20 July 2012  
EL&P-022-12

SUBJECT: Amendment Request for Certificate of Compliance No. 9204 for the  
Model 10-160B Package  
Docket No. 71-9204

EnergySolutions requests an amendment to Certificate of Compliance No. 9204 for the Model 10-160B Package allowing addition of a Thermal Shield as a component of the package. EnergySolutions provides the attached revision of the Safety Analysis Report (SAR), Consolidated Revision 4, and drawings as supporting information to our amendment request. The revision and drawings address the thermal issues that have been the subject of several recent discussions. Only those parts of the SAR affected by addition of the thermal shield have been revised. The included Revision Control Sheet identifies the specific sections of the SAR that have been revised. Please replace the identified sections with those in this submittal.

Figure 3.6

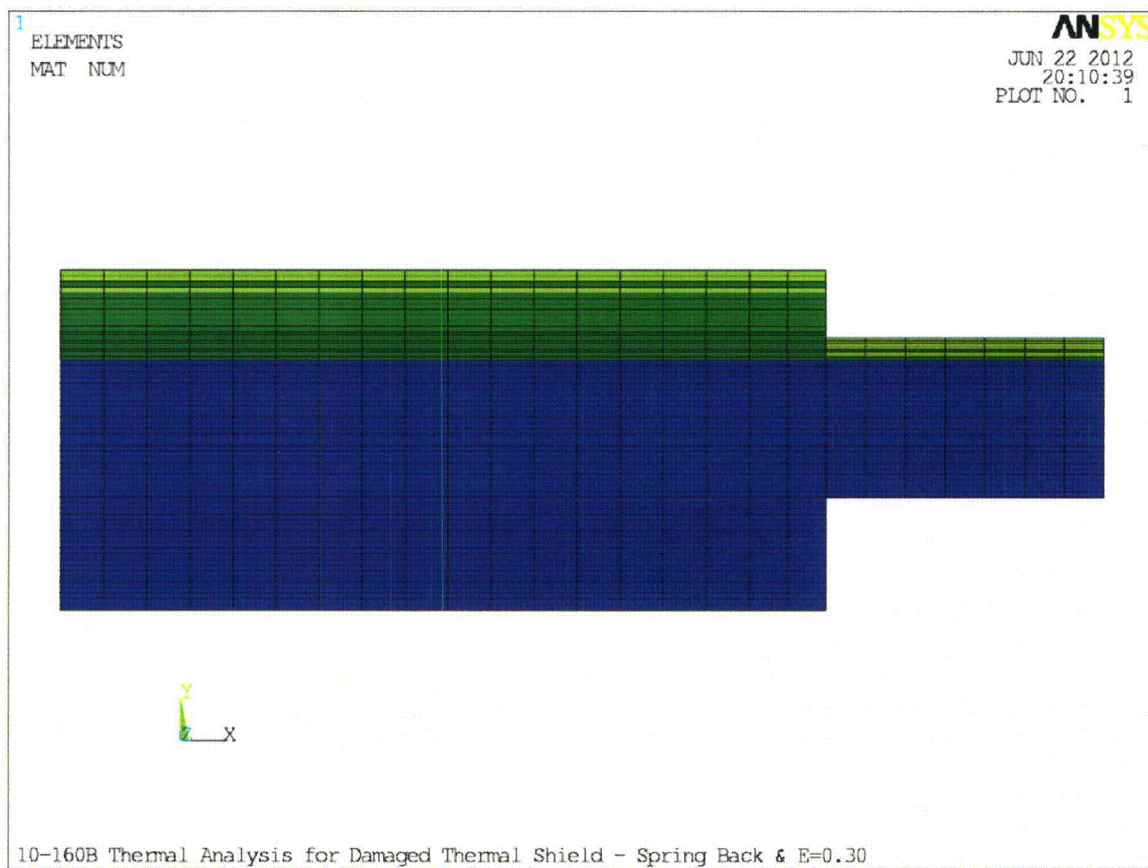
The scenario in which the hollow central portion of the impact limiters is breached during the puncture drop test that precedes the fire test has been analyzed in EnergySolutions document TH-0002 (Reference 12). In Reference 12 a finite element model of the secondary lid with the thermal shield is analyzed for the HAC fire test. The finite element model is reproduced in Figure 3-6. The temperature

time-history plot of the representative seal locations is shown in Figure 3-7. Figure 3-8 shows the temperature contour plot of the secondary lid with the thermal-shield at the end of the 30 minute fire.
